PCN #: 2554

PCN Title: Qualified Additional Assembly & Test Sites, Bill of Material and updated Device Data Sheets for Package Outline Dimension Change

PRODUCT CHANGE NOTICE**PCN-2554 REV 1**

Table 5 – POD Change for SOT353-5L

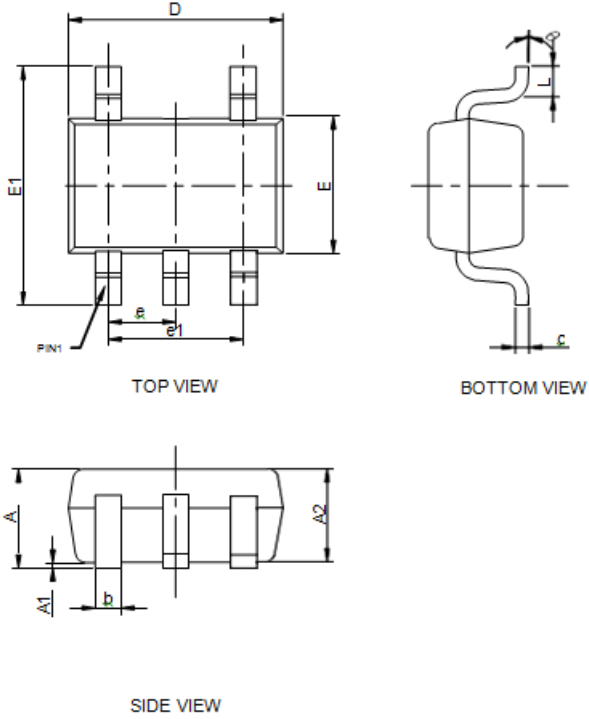
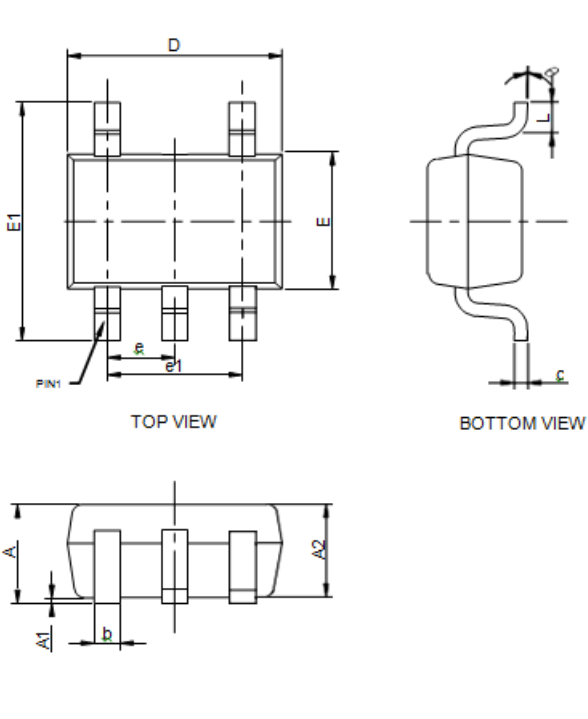
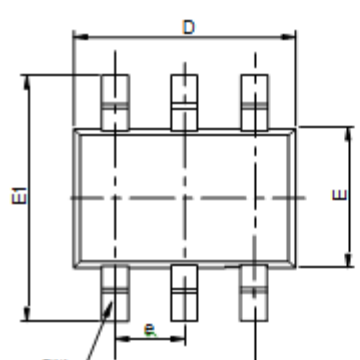
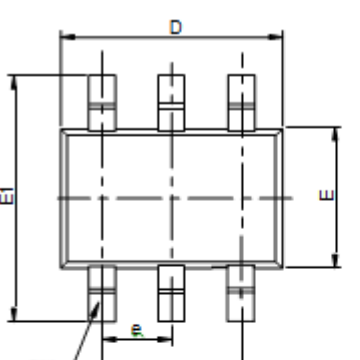
Current POD	New POD																																																																																				
 <p>TOP VIEW</p> <p>BOTTOM VIEW</p> <p>SIDE VIEW</p>	 <p>TOP VIEW</p> <p>BOTTOM VIEW</p> <p>SIDE VIEW</p>																																																																																				
<table border="1" style="margin: auto; border-collapse: collapse;"> <thead> <tr> <th colspan="3">PKG. DIMENSIONS (MM)</th> </tr> <tr> <th>SYMBOL</th> <th>Min</th> <th>Max</th> </tr> </thead> <tbody> <tr><td>A</td><td>-</td><td>1.10</td></tr> <tr><td>A1</td><td>0.00</td><td>0.10</td></tr> <tr><td>A2</td><td>0.70</td><td>1.00</td></tr> <tr><td>b</td><td>0.15</td><td>0.30</td></tr> <tr><td>c</td><td>0.08</td><td>0.22</td></tr> <tr><td>D</td><td>1.80</td><td>2.20</td></tr> <tr><td>E</td><td>1.10</td><td>1.40</td></tr> <tr><td>E1</td><td>1.80</td><td>2.40</td></tr> <tr><td>e</td><td colspan="2" style="text-align: center;">0.65 BSC</td></tr> <tr><td>e1</td><td colspan="2" style="text-align: center;">1.30 BSC</td></tr> <tr><td>L</td><td>0.26</td><td>0.46</td></tr> <tr><td>θ</td><td>0</td><td>8</td></tr> </tbody> </table>	PKG. DIMENSIONS (MM)			SYMBOL	Min	Max	A	-	1.10	A1	0.00	0.10	A2	0.70	1.00	b	0.15	0.30	c	0.08	0.22	D	1.80	2.20	E	1.10	1.40	E1	1.80	2.40	e	0.65 BSC		e1	1.30 BSC		L	0.26	0.46	θ	0	8	<table border="1" style="margin: auto; border-collapse: collapse;"> <thead> <tr> <th colspan="3">PKG. DIMENSIONS (MM)</th> </tr> <tr> <th>SYMBOL</th> <th>Min</th> <th>Max</th> </tr> </thead> <tbody> <tr><td>A</td><td>-</td><td>1.10</td></tr> <tr><td>A1</td><td>0.00</td><td>0.10</td></tr> <tr><td>A2</td><td>0.70</td><td>1.00</td></tr> <tr><td>b</td><td>0.15</td><td>0.30</td></tr> <tr><td>c</td><td>0.08</td><td>0.22</td></tr> <tr><td>D</td><td>1.80</td><td>2.20</td></tr> <tr><td>E</td><td>1.10</td><td>1.40</td></tr> <tr><td>E1</td><td style="color: red;">2.15</td><td style="color: red;">2.45</td></tr> <tr><td>e</td><td colspan="2" style="text-align: center;">0.65 BSC</td></tr> <tr><td>e1</td><td colspan="2" style="text-align: center;">1.30 BSC</td></tr> <tr><td>L</td><td>0.26</td><td>0.46</td></tr> <tr><td>θ</td><td>0</td><td>8</td></tr> </tbody> </table>	PKG. DIMENSIONS (MM)			SYMBOL	Min	Max	A	-	1.10	A1	0.00	0.10	A2	0.70	1.00	b	0.15	0.30	c	0.08	0.22	D	1.80	2.20	E	1.10	1.40	E1	2.15	2.45	e	0.65 BSC		e1	1.30 BSC		L	0.26	0.46	θ	0	8
